**DESIGN-BUILD REPLACEMENT OUTDOOR DIGITAL SIGNAGE
LYNX CENTRAL STATION
RFP 18-R03
ADDENDUM NUMBER TWO (2)
DECEMBER 9, 2017**

Sheet No.
E1.01

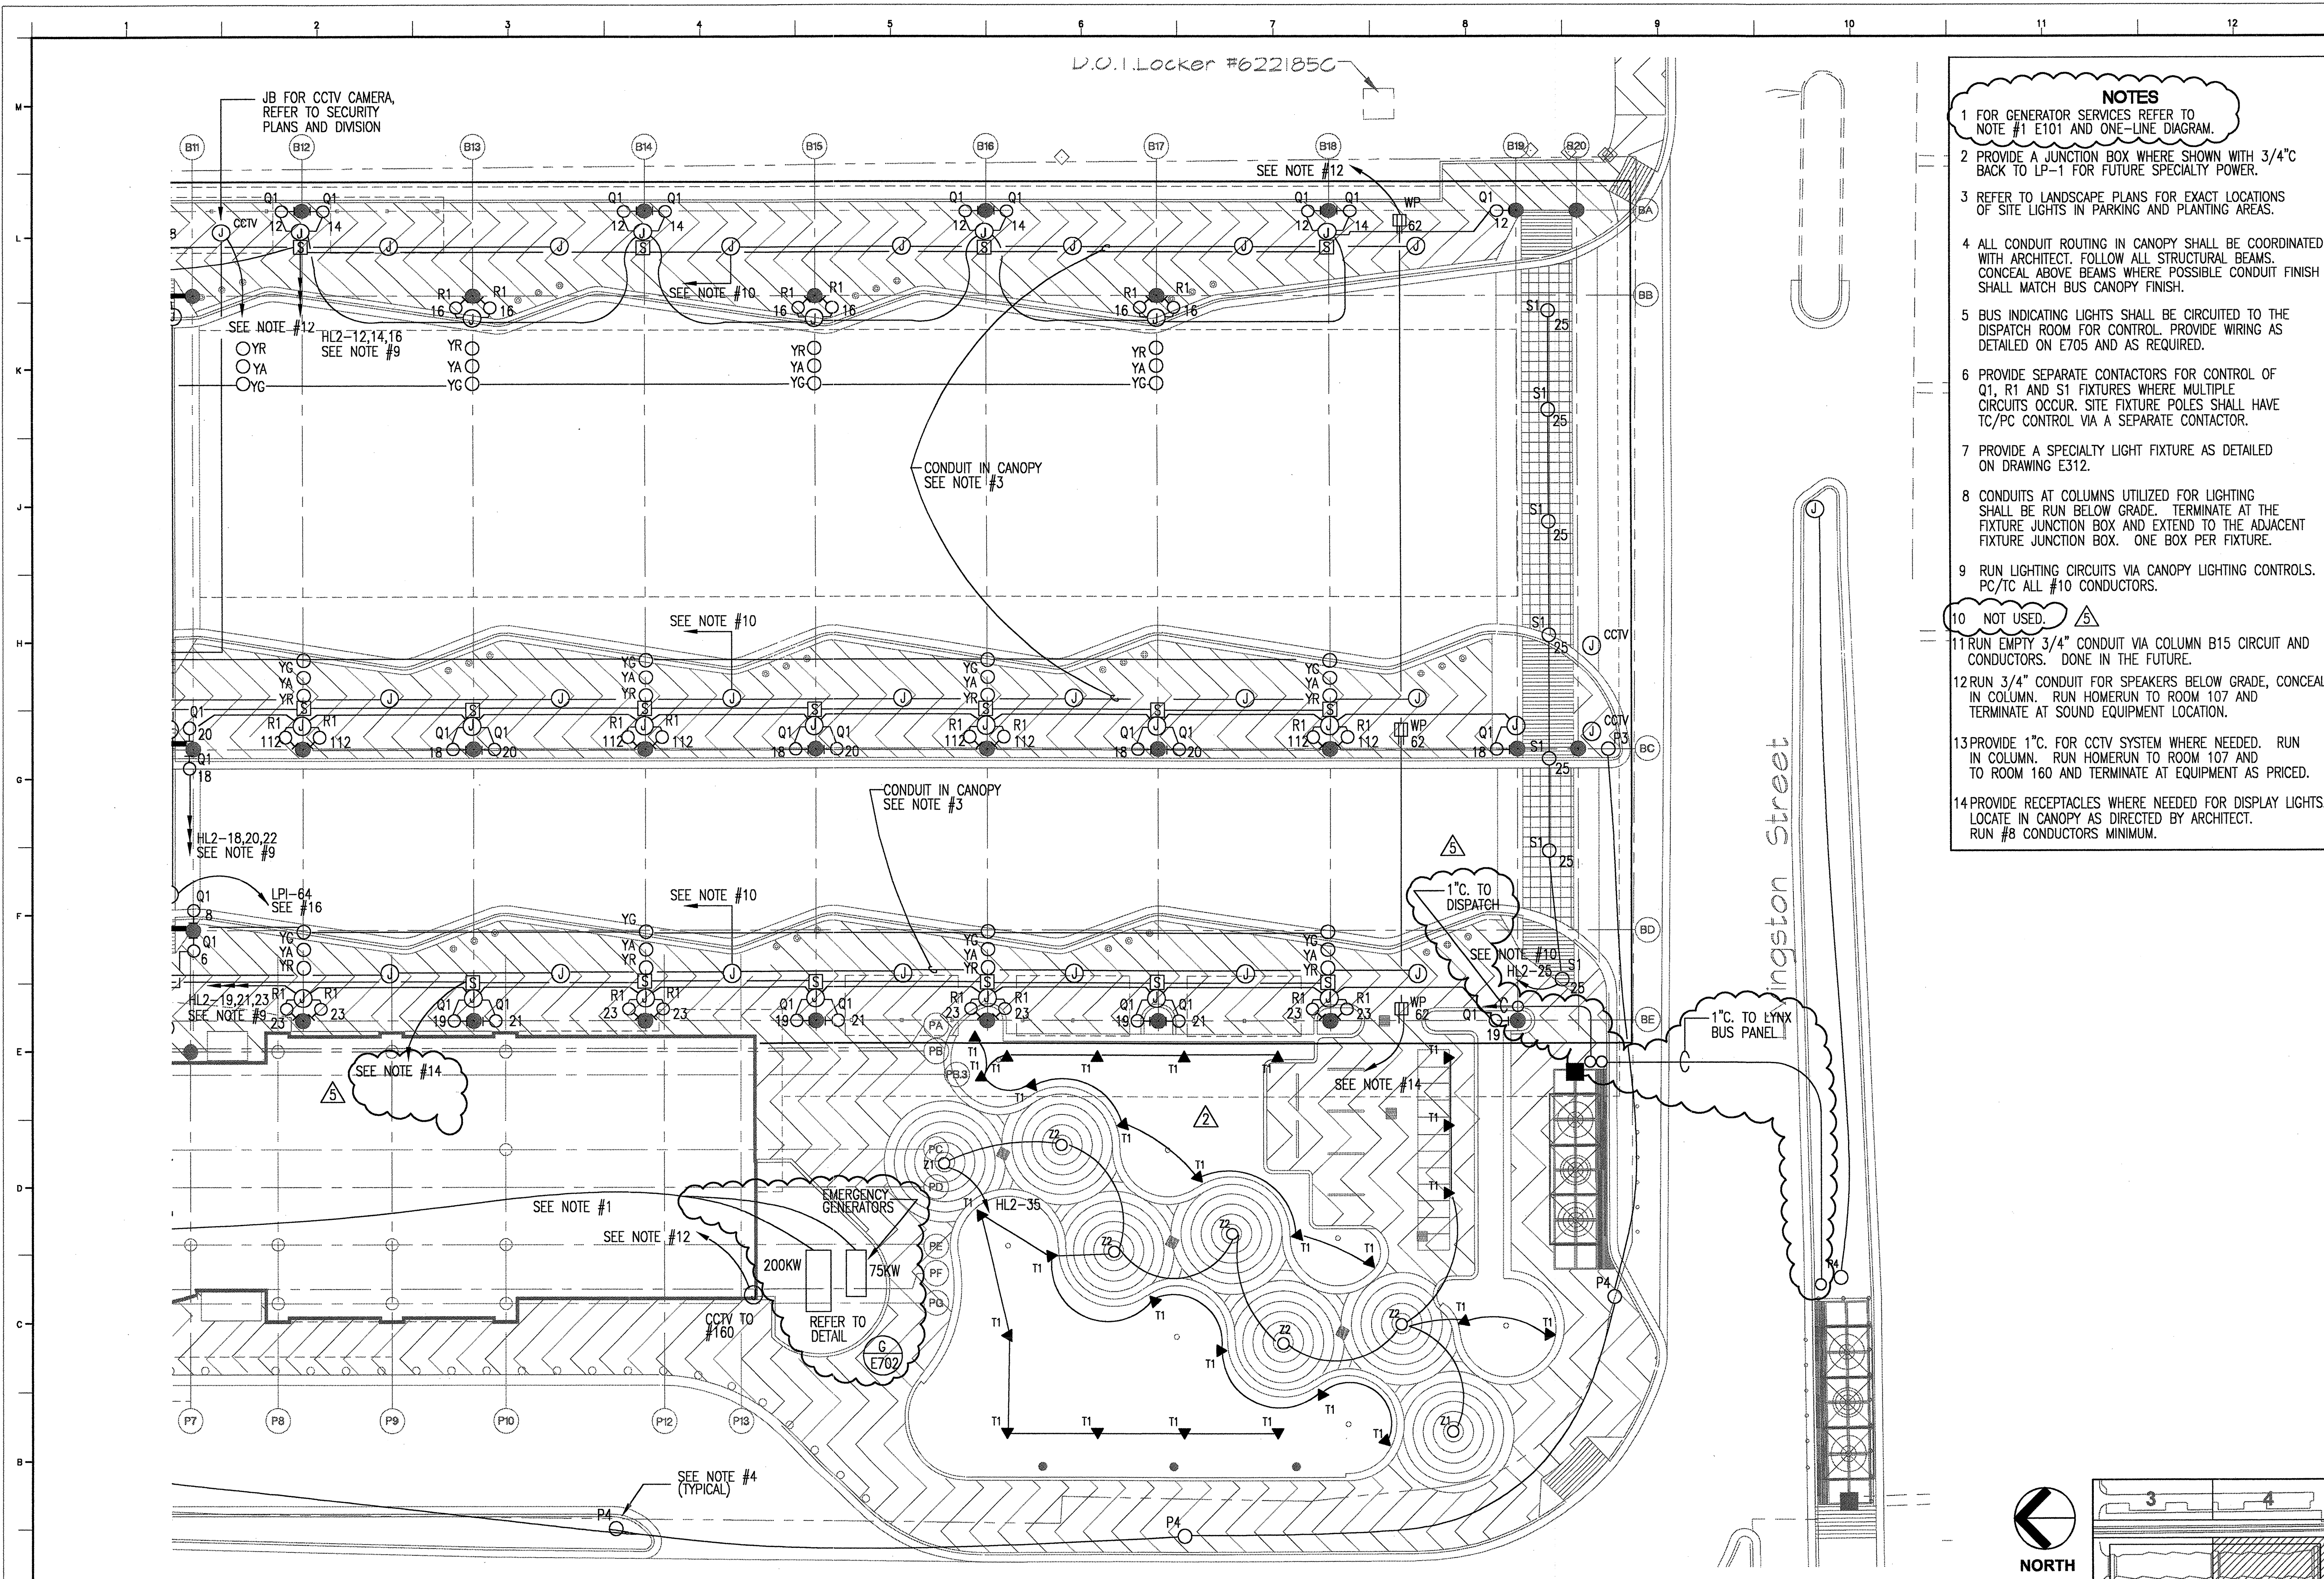
17) Question: Can Lynx provide any existing electrical and network drawings for the LCS?

Response: Please reference the attached plans:

Response: Please refer to the documents referenced in Question 12.

G-35

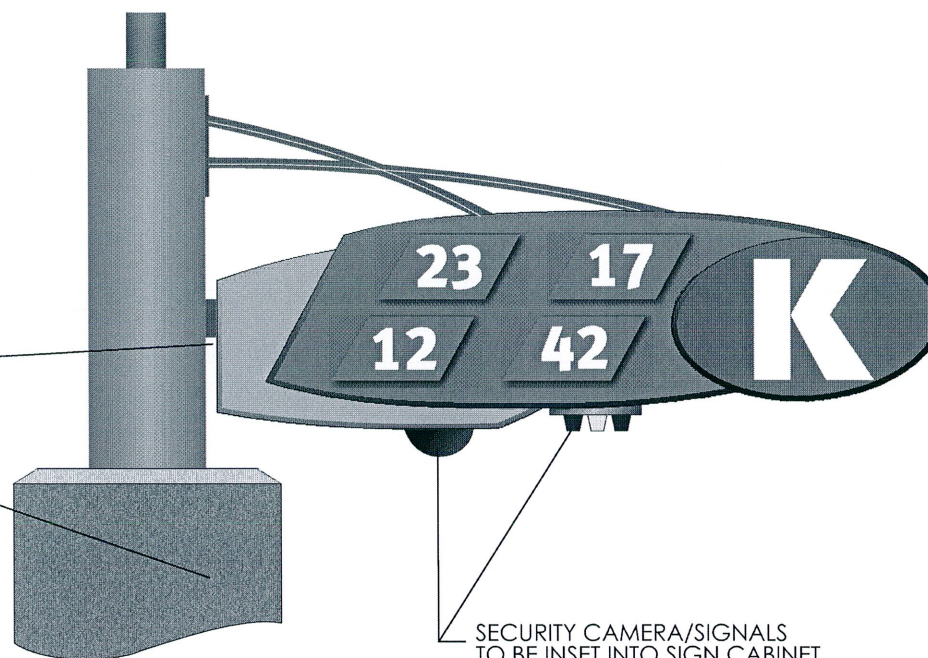
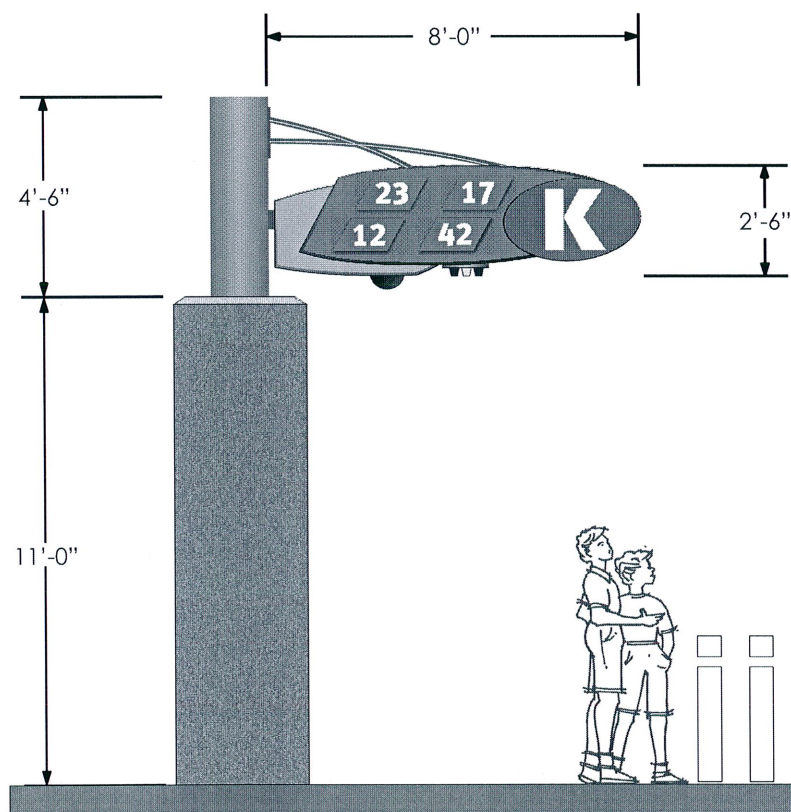
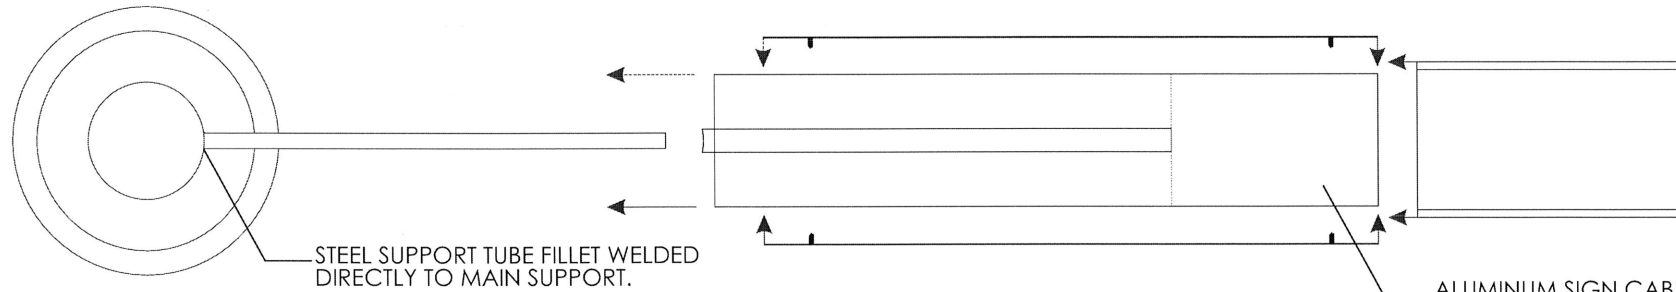
12) Question: Can LYNX provide mechanical drawings and structural details of the pillars and existing signage?

13) Question: Can LYNX provide paint color spec used for LCS and for the existing signage?

14) Question: Can LYNX provide a site drawing and identify any mandatory clearances that must be maintained in the areas around the pillars, i.e. maximum height, minimum clearance below, or distance from curbs, etc.

Response: Please reference the attached International Sign & Design pages G-35 and G-36.1.

Response: Reference International Sign & Design pages G-35 and G-36.1 for existing clearances. LYNX requires a vertical clearance from concrete floor to bottom of sign.
